**Subject: San Onofre Nuclear Generating Station Unit 2
Docket No. 50-361
Proposed Change Number NPF-10-540
License Amendment Request, "Reactor Coolant System (RCS)
Pressure and Temperature Limits Report (PTLR)"**

**PROPOSED CHANGE NUMBER (PCN) – 540
REMOVAL OF REACTOR COOLANT SYSTEM (RCS) PRESSURE
AND TEMPERATURE CURVES FROM THE TECHNICAL SPECIFICATIONS
TO A PRESSURE AND TEMPERATURE LIMITS REPORT (PTLR)**

**DESCRIPTION AND NO SIGNIFICANT HAZARDS ANALYSIS
FOR PROPOSED CHANGE NPF-10-540
REMOVAL OF REACTOR COOLANT SYSTEM (RCS) PRESSURE AND
TEMPERATURE CURVES FROM THE TECHNICAL SPECIFICATIONS TO A
PRESSURE AND TEMPERATURE LIMITS REPORT (PTLR)
San Onofre Nuclear Generating Station Unit 2**

Figure 3.4.3-1

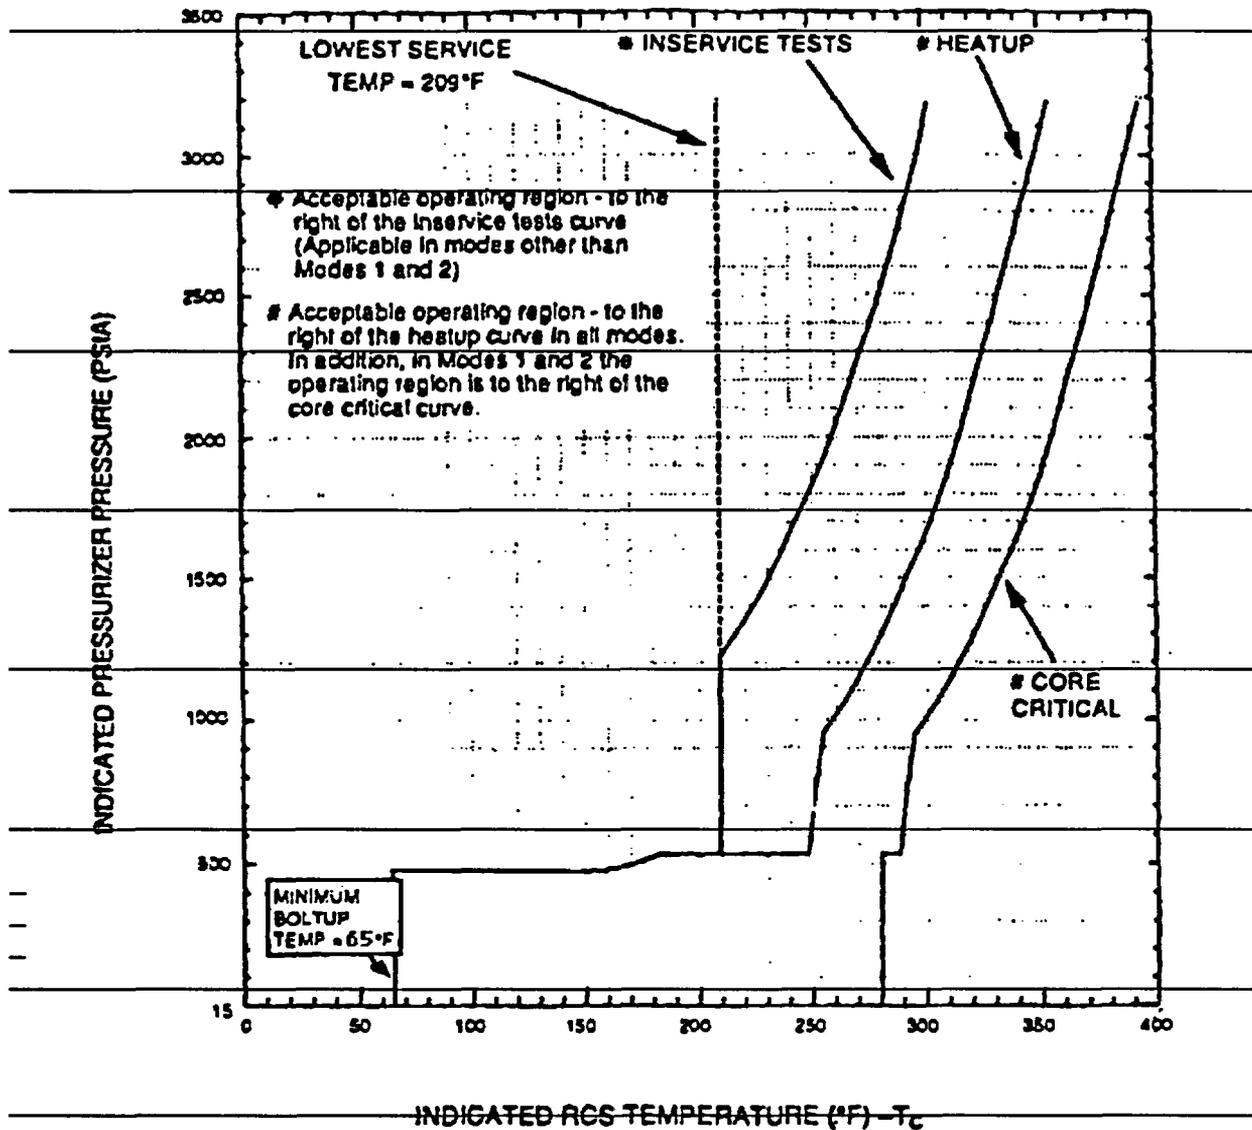
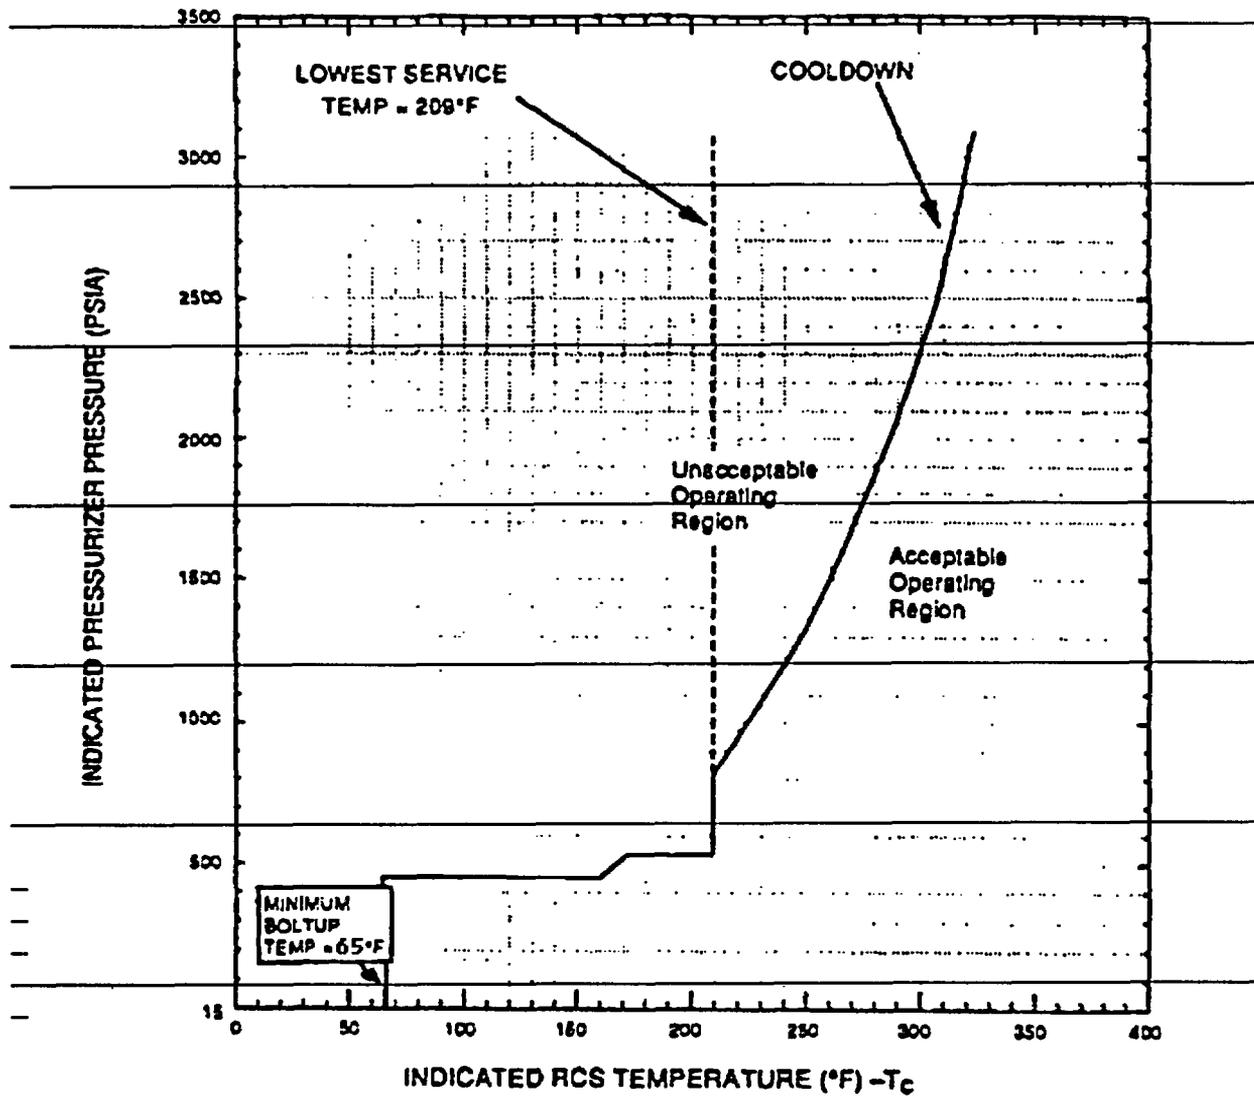
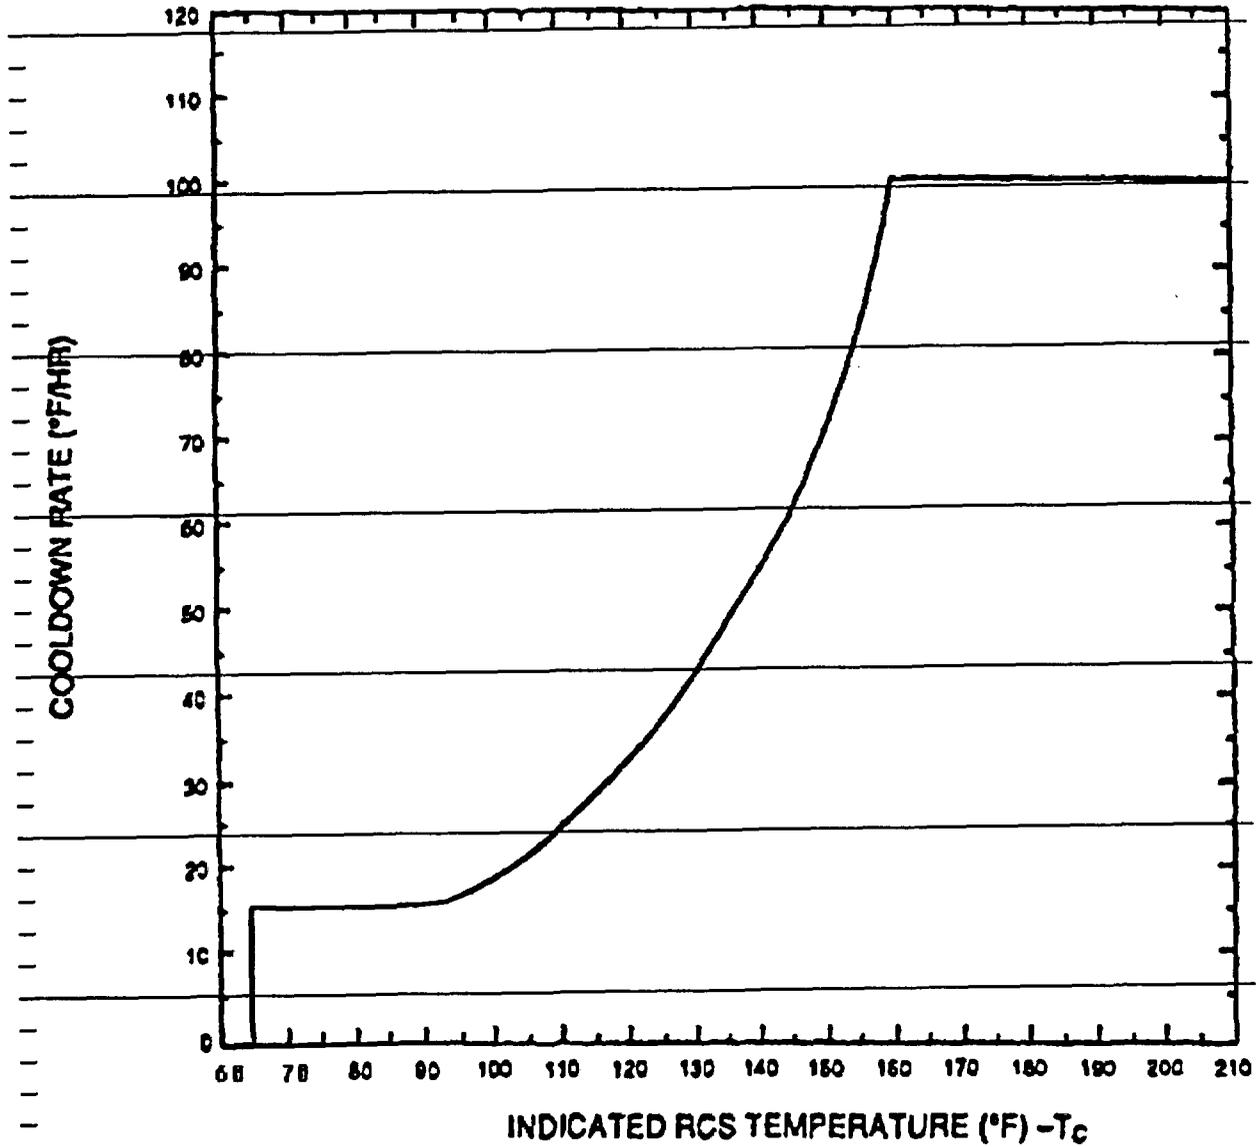
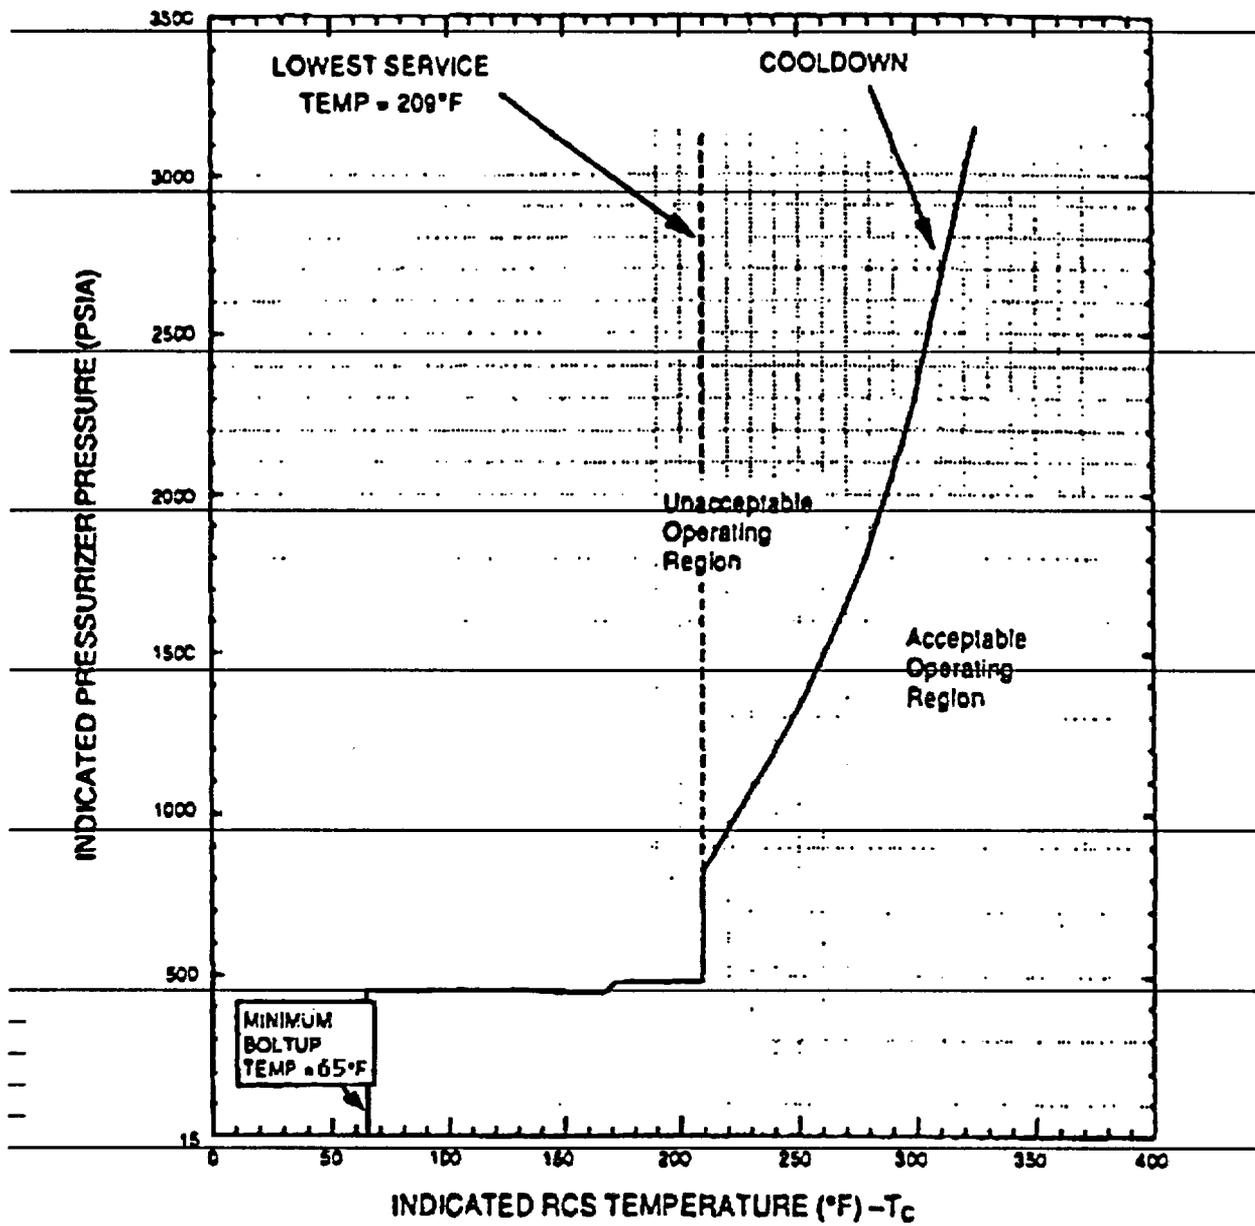
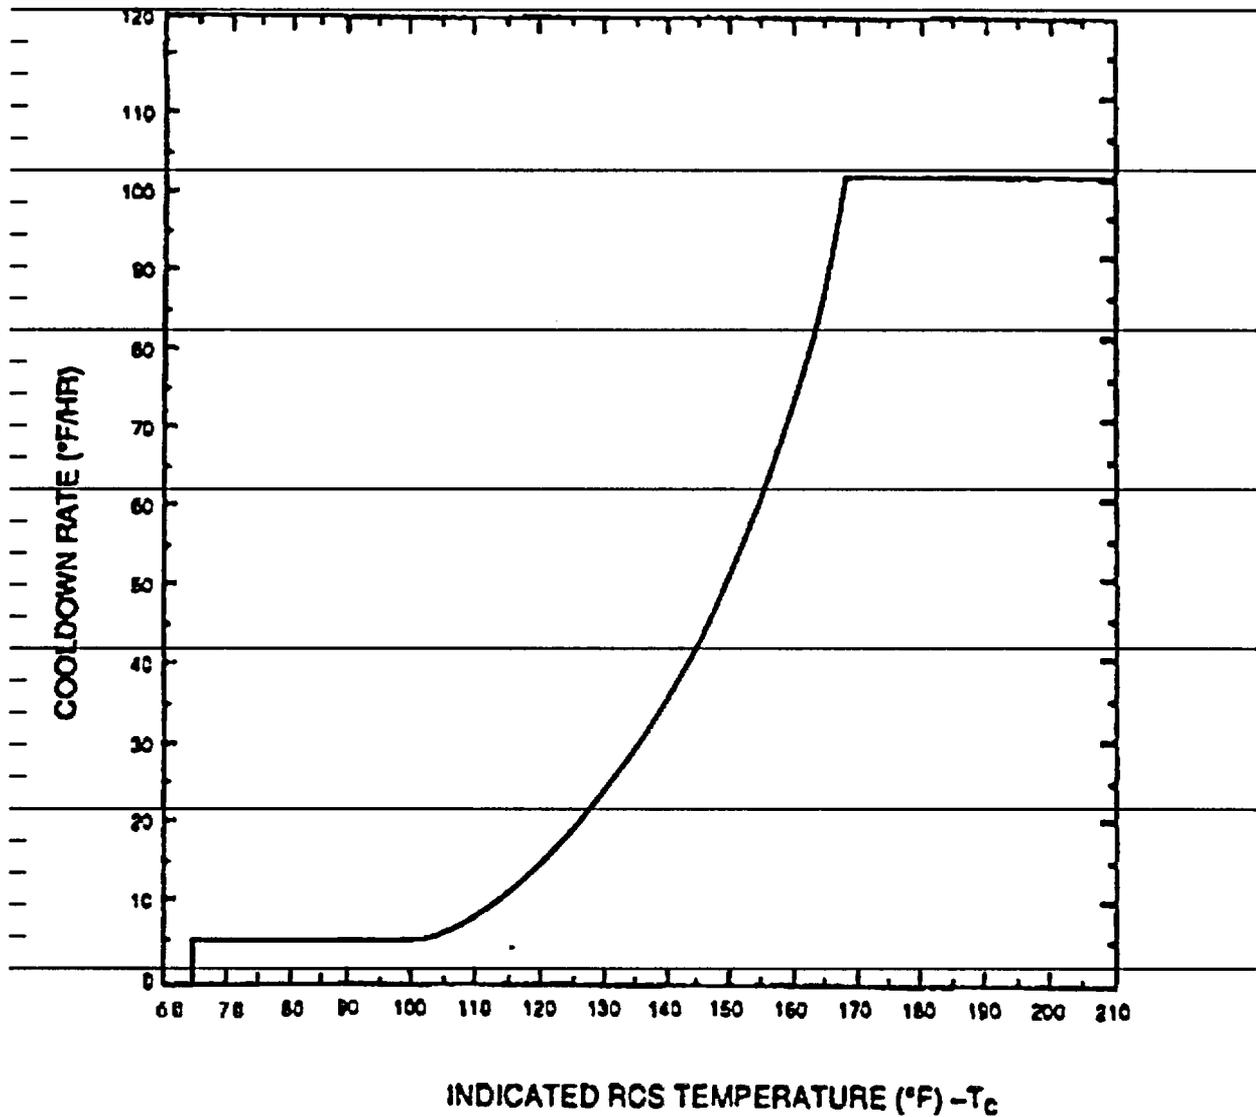
- ~~a. A maximum heatup of 60°F in any 1-hour period with RCS cold leg temperature greater than or equal to 65°F.~~
- ~~b. A maximum cooldown as specified by Figure 3.4.3-3 in any 1-hour period with RCS cold leg temperature less than or equal to 160°F. A maximum cooldown of 100°F in any 1-hour period with RCS cold leg temperature greater than 160°F.~~
- ~~c. A maximum temperature change of 10°F in any 1-hour period during inservice hydrostatic and leak testing operations above the heatup and cooldown limit curves.~~
- ~~d. A minimum temperature of 65°F to tension reactor vessel head bolts.~~

~~NOTE: A MAXIMUM COOLDOWN RATE OF 100°F/HR IS ALLOWED
AT ANY TEMPERATURE ABOVE 160°F~~

~~FIGURE 3.4.3-3~~

~~SONGS 2 RCS PRESSURE/TEMPERATURE LIMITS
MAXIMUM ALLOWABLE COOLDOWN RATES (UNTIL 20 EFPY)
Normal Operation~~

Figure 3.4.3-1
DELETED

FIGURE 3.4.3-2
DELETED

FIGURE 3.4.3-3
DELETED

FIGURE 3.4.3-4
DELETED

FIGURE 3.4.3-5
DELETED
